Access Compliance Report

Public Rights-of-Way

Intersection ID: 12344	Main Street: REMOUNT_RD	Cross Street: GREENLAND_AV	Location: NW
ADA ID: 544246A901B6	Ramp Type: Perp	Initial Pass/Fail: Fail	Overall Compliance: No
		Severity Score: 8.75

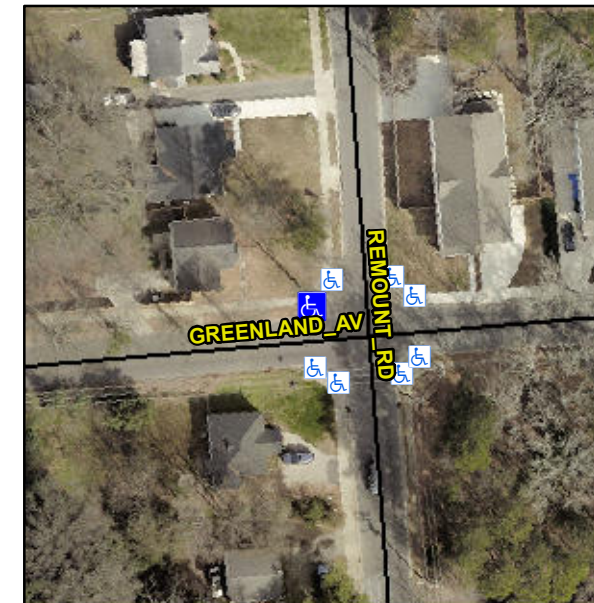
Not Found, R304.5.1

Compliance	Description	Data	Compliance	Description	Data
N/A	Ramp Length (in)	67.5	Yes	Ramp Slope (%)	7.3
No	Ramp Width (in)	47.5	Yes	Ramp XSlope (%)	1.9
N/A	Flare Type LT	N/A	N/A	Flare Type RT	N/A
N/A	Flare Slope LT (%)	N/A	N/A	Flare Slope RT (%)	N/A
N/A	Flare Traversable LT?	N/A	N/A	Flare Traversable RT?	N/A
N/A	Landing Length (in)	N/A	N/A	DWS Provided?	N/A
N/A	Landing Width (in)	N/A	N/A	DWS Contrast?	N/A
N/A	Landing Slope (%)	N/A	N/A	DWS Length (in)	N/A
N/A	Landing X Slope (%)	N/A	N/A	DWS Full Width?	N/A
N/A	Landing Curb? (Y/N)	N/A	N/A	DWS Offset (in)	N/A
N/A	Shared Landing?	N/A			
N/A	Gutter Ponding?	N/A	N/A	Gutter Slope (%)	N/A
N/A	Gutter Lip Ht (in)	N/A	N/A	Gutter X Slope (%)	N/A
N/A	Painted X Walk1?	No	N/A	Painted X Walk2?	N/A
	X Walk 1 Direction	To S		X Walk 2 Direction	N/A
N/A	X Walk 1 Width (in)	N/A	N/A	X Walk 2 Width (in)	N/A
	X Walk 1 Slope (%)	0.4		X Walk 2 Slope (%)	N/A
	X Walk 1 X Slope (%)	2.7		X Walk 2 X Slope (%)	N/A

Remove & Replace Entire Ramp.
